UNITED STATES PATENT AND TRADEMARK OFFICE

| APPLICATION NO. | FILING DATE | FIRST NAMED INVENTOR | ATTORNEY DOCKET NO. | CONFIRMATION NO. |
|--|-------------|--------------------------|-------------------------------|------------------|
| 10/805,869 | 03/22/2004 | Joseph Gerard Birmingham | BIRM3002/TJM | 1786 |

| Office Action Summary | Application No. 10/805,869 | Applicant(s) BIRMINGHAM ET AL. | |

DETAILED ACTION

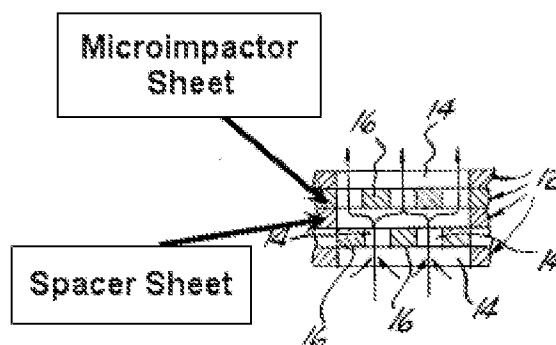
Regarding claim 23, Spencer further teaches the first spacer sheet has a first thickness of 51 microns, each of the first, second and third spacing is 89 microns, each of the first and second microimpactor sheets has a thickness of 51 microns (col. 2, lines 56-60). Spencer does not teach each of the first and second microimpactors having a width of about 10-150 microns or the third and fourth microimpactor having a width different from the first width and the fourth, fifth and sixth spacing having a different spacing than the first, second and third spacing.

Spencer teaches the first and second microimpactors having a width of 254 microns. The only difference between the prior art and the invention as claimed in a recitation of relative dimension. [W]here the only difference between the prior art and the claims was a recitation of relative dimensions of the claimed device and a device having the claimed relative dimensions would not perform differently than the prior art device, the claimed device was not patentably distinct from the prior art device, *Gardner v. TEC Systems, Inc.*, 220 USPQ 777 (1984).

Uram teaches a microimpactor having microimpactor sheets with different spacing sizes than other sheets. (col. 3, lines 58-68). It would have been obvious to one of ordinary skill in the art at the time the invention was made to use different widths and spacing as taught by Uram because it provides successive filtering layers where different sized particles are trapped at different layers of the filter, this feature being well known in the filter art.
